# DOW CHEMICAL TRIGA
# RESEARCH REACTOR
# LICENSE NO. R-108
# DOCKET NO. 50-264

## REVISED SAFETY ANALYSIS REPORT, TECHNICAL SPECIFICATIONS, AND RAI RESPONSES (2/11/2011)

Subject: Dow Chemical Company- Response to the Request for Additional Information for the renewed license of the TRIGA research reactor. License No. R-108; Docket No. 50-264

Response to the request for additional information
The Dow Chemical Company
February 2011

Figure 4. Upper grid

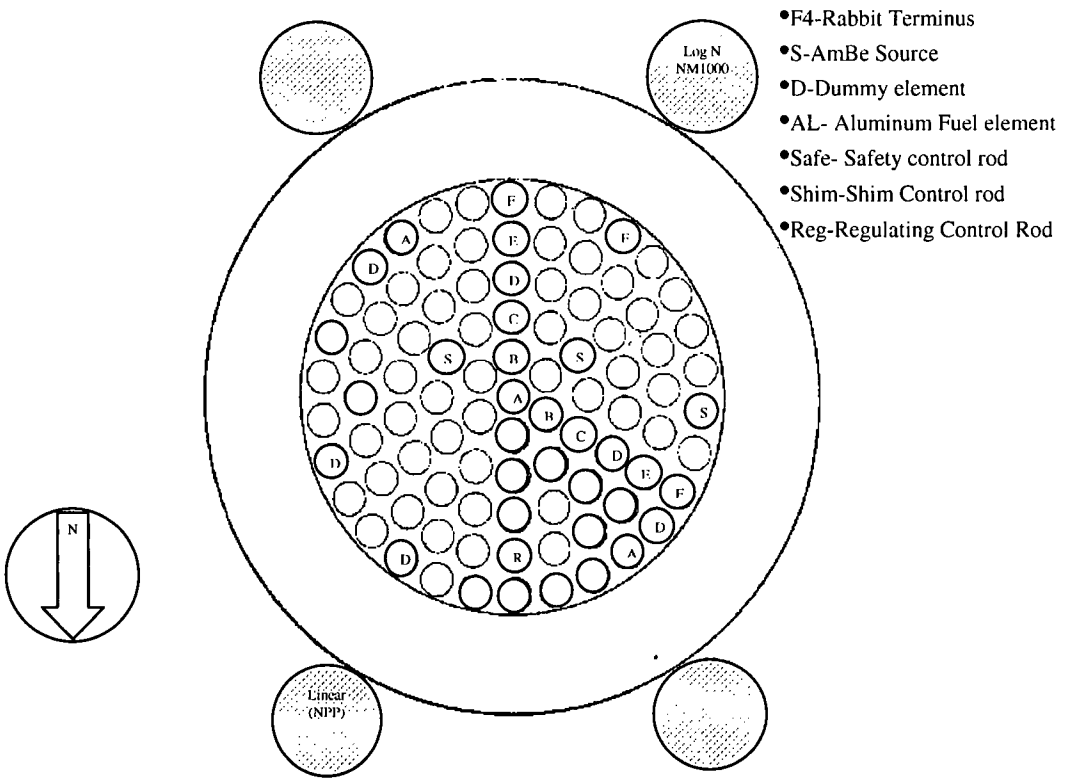
11. NUREG–1537, Part 1, Section 4.2.5, "Core Support Structure" requests the applicant to provide design information pertaining to the core support structure. DTRR SAR, Chapter D, does not provide sufficient information. Please provide figures depicting the upper and lower core plates and provide the dimensions and locations of all penetrations that allow coolant to flow through them.

DTRR response:
Two aluminum grid plates fix the position of fuel elements, dummy elements and neutron source. Figure 4 is the schematic drawing of the upper grid plate with the position of the control rods, pneumatic transfer location and source indicated. The upper plate is ¾ inch aluminum and 1.5 inch diameter holes to position the fuel, dummy elements, control rods, etc. The bottom plate is ¾ inch aluminum and has holes to receive the end pins of the fuel and dummy elements. Thirty-six holes for the natural convection cooling are found on the lower grid plate. The water passes through the upper grid plate by means of the gap between the triflute section of the fuel and the upper grid plate. The penetrations on the lower grid plate are in concentric rings with 7, 12, and 17 holes, respectively. Figure 5 is a photograph of the lower grid plate. This photograph substantiates the as built drawings given by General Atomics, and previous Safety Analysis Reports submitted by The Dow Chemical Company. Figure 5 is a photograph of the lower grid plate.

Figure 6. Block Diagram Cooling System
A,B,C, and D are valves that can be used for isolation

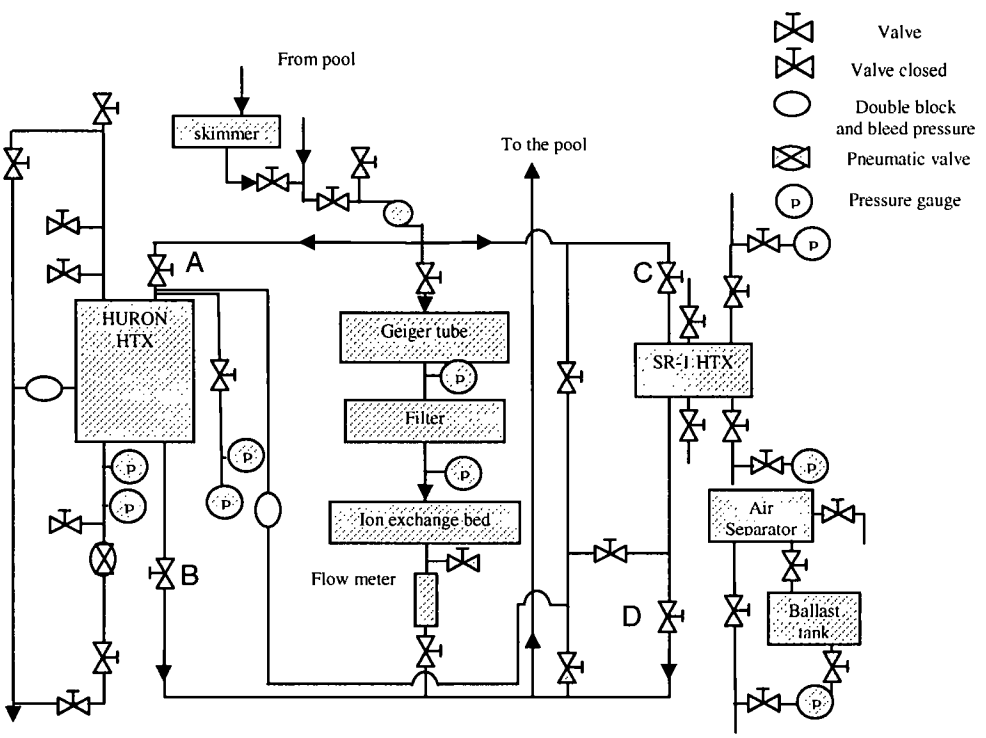
23.1 DTRR SAR, Section E.1, states that "the heat rejection systems can be operated independently or in tandem." DTRR SAR, Section E.1, Figure 6, Reactor Coolant System, shows no valve arrangement that

accomplishes these functions. Please provide schematics and flow diagrams for the secondary system, including valves, which show how the secondary coolant system can be operated independently or in tandem.

23.2 DTRR SAR, Section E.1, does not provide sufficient information describing the secondary system. Please provide a more detailed description of the secondary coolant system and describe how primary to secondary leakage would be detected.

23.2 Figure 6 is of the heat exchange system installed at the DTRR. The reactor is cooled by natural convection. Thus, the system is not required for operation.

23.3 Makeup water is added directly to the pool and monitored. Pressure in pool water lines and coolant lines are monitored. The pool water line is kept at a lower pressure than the coolant lines. Huron water leaking into the pool would be indicated by changes in conductivity, pH, monthly water sampling and the Geiger tube installed on the water treatment line. Leaks would also be indicated by changes in pressure monitored on the system. The secondary heat exchange system is rated at 1 megawatt. The chiller is a located on the east side of building 1602. This system can be operated manually or set to automatically start when the pool water reaches 27 °C. The system shuts down at 22 °C. The system is dedicated to the reactor. The uncertainty in the measurement is 2 °C.

Figure 7. Detector ranges

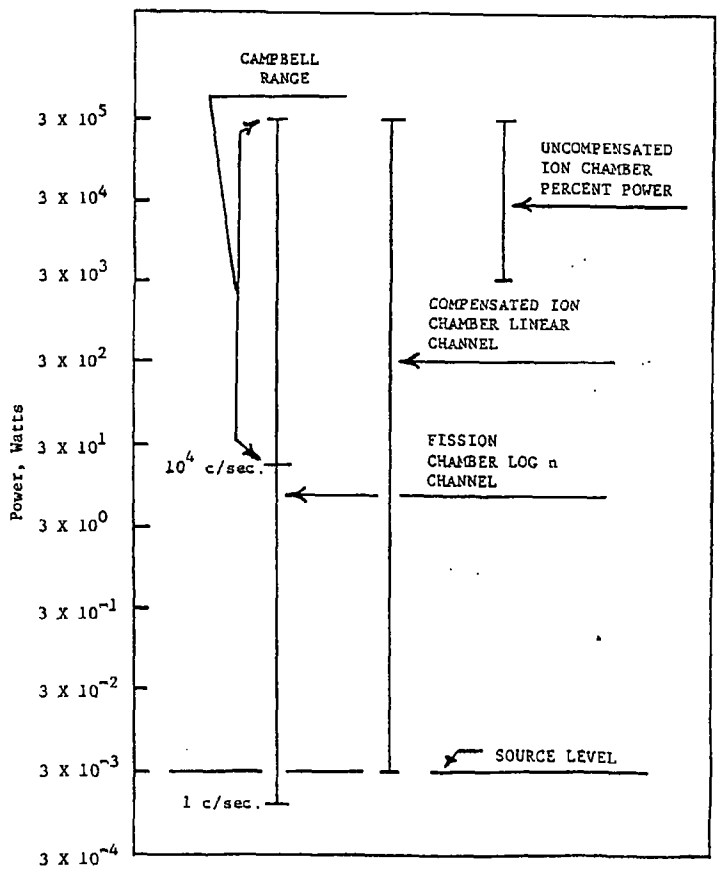
30. NUREG–1537, Part 1, Section 7.3, "Reactor Control Systems (RCS)" requests the applicant to provide information regarding the functions of the RCS. DTRR SAR, Chapter G, does not provide sufficient information.

DTRR response:
General Atomics provided both the NM1000, and NPP1000 used as power

monitors for the DTRR. The combined range of the two instruments covers from $3 \times 10^{-4}$ up to $3 \times 10^{5}$ Watts. Figure 7 is the range of the two instruments.

Figure 9. Block Diagram of the console

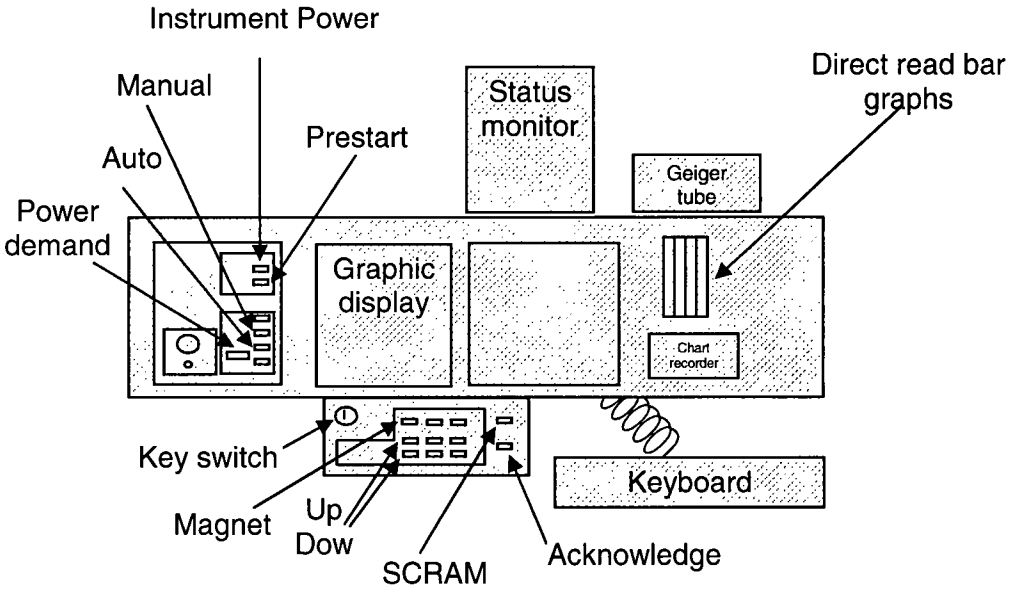
32.3 Please provide drawings or photographs showing the arrangement of the display instruments and console control equipment.

32.3 Figure 9 is a block diagram of the console.

Figure 11. HVAC for the DTRR reactor room.

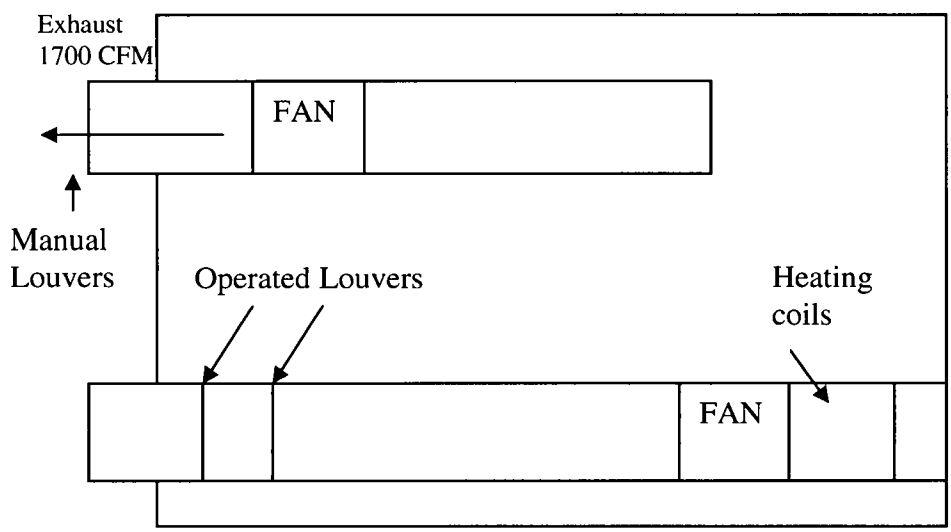
34. NUREG–1537, Part 1, Section 9.1, "Heating, Ventilation and Air Conditioning System" requests the applicant to provide a description of the heating, ventilation and air conditioning system (HVAC) and any manual or automatic functions. There is a brief description in DTRR SAR I.1 regarding this function with no schematics or illustrations. Please provide a more detailed description of the HVAC system and system functions and provide schematics of the HVAC system.

The HVAC for DTRR is Figure 11. The inlet to the reactor room is located to the north side of the reactor room. The outlet is located on the east wall of the building. The ventilation system inlet is equipped with a set of louvers that can be shut from the control room by the operator if necessary to isolate the reactor room. The exhaust is also equipped with a set of louvers that can be shut manually from the exterior of the building. The fume hood exhausts are separate from the HVAC system.

Pool water temperature - less than 60 °C
Pool water height above core - 15 feet above the core
Pool water conductivity - less than 5μmhos
Radioactivity in the water - less than 0.1μCi/ml

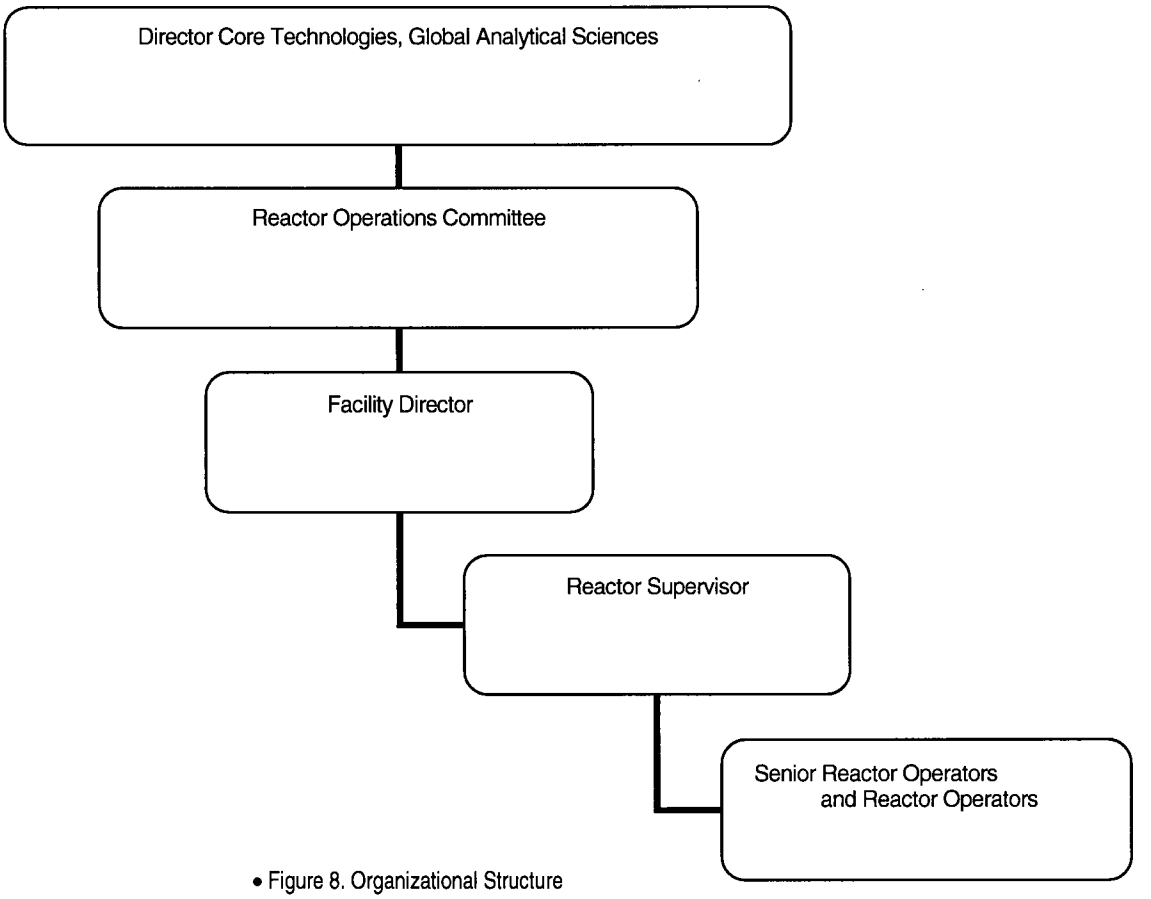
48. NUREG–1537, Part 1, Section 12.1 "Organization" requests the applicant to provide a description of the organizational structure, responsibilities, and staffing, including the selection and training of personnel. DTRR SAR, Section L.1, Figure 8, "Organizational Structure," does not agree with DTRR TS 6.1, "Organization," Figure 6.1. The duties of the Facility Director are not described. Please provide clarification of the differences in the two organization charts and describe the duties of the Facility Director.

DTRR response:
The organizational chart provided in Figure 8 of the SAR is the management structure for the reactor personnel. DTRR TS 6.1 also indicates the relationship of the Reactor Operations to the Radiation Safety Officer. The facility director is responsible for the reactor facility operations.

Figure 6.1. Administration

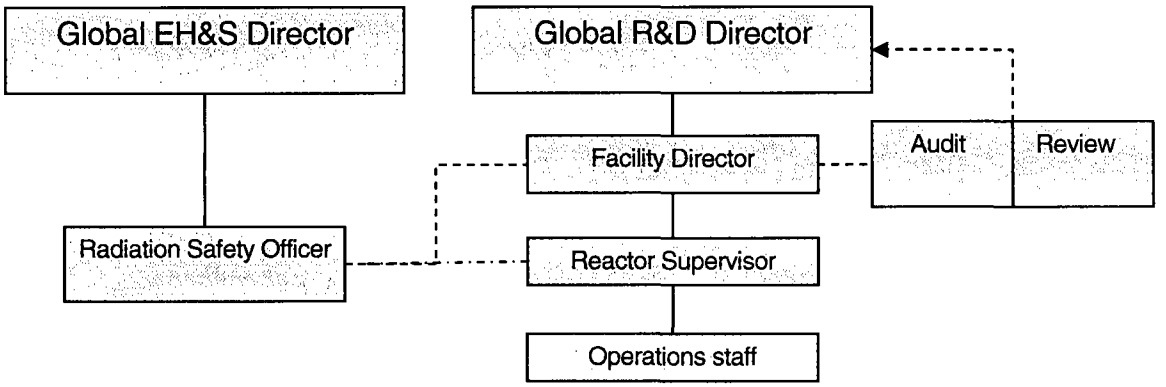
65.1 ANSI/ANS-15.1-2007, Section 6.1, "Organization" recommends organizational structures including levels and reporting authority. DTRR TS Figure 6.1, the DTRR organization structure, includes no level 3 or 4 staff and differs from Figure

65.1. Figure 8 of the SAR is the reporting structure for the reactor operations staff and does not include the reporting structure for the Radiation Safety Officer. Figure 6.1 of the TS has been changed to comply with ANSI/ANS-15.1. Figure 6.1 includes the chain of command for the Radiation Safety Officer.
